-	Application No.	Applicant(s)
Notice of Allowability	10/939 044	SUZUK TATSUTOSU
	10/828,911 Examiner	SUZUKI, TATSUTOSHI Art Unit
	Erica E. Cadugan	3722
The MAILING DATE of this communication appears on the cover sheet with the correspondence address All claims being allowable, PROSECUTION ON THE MERITS IS (OR REMAINS) CLOSED in this application. If not included herewith (or previously mailed), a Notice of Allowance (PTOL-85) or other appropriate communication will be mailed in due course. THIS NOTICE OF ALLOWABILITY IS NOT A GRANT OF PATENT RIGHTS. This application is subject to withdrawal from issue at the initiative of the Office or upon petition by the applicant. See 37 CFR 1.313 and MPEP 1308.

EXAMINER'S AMENDMENT

2. The following is an examiner's statement of reasons for allowance:

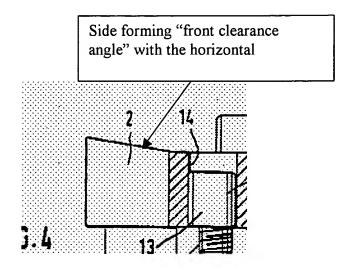
As viewed in the partial reproduction of Figure 6 from the Niman reference below, the "front clearance angle" is the angle that the side labeled as "63" makes with the horizontal.

As viewed in the partial reproduction of Figure 4 below, the "front clearance angle" is the angle that the labeled side makes with the horizontal.

In neither of Niman nor Hofmann is this angle shown to be within the claimed range, noting that in both cases, the angle is clearly shown at an angle significantly less than 45 degrees.
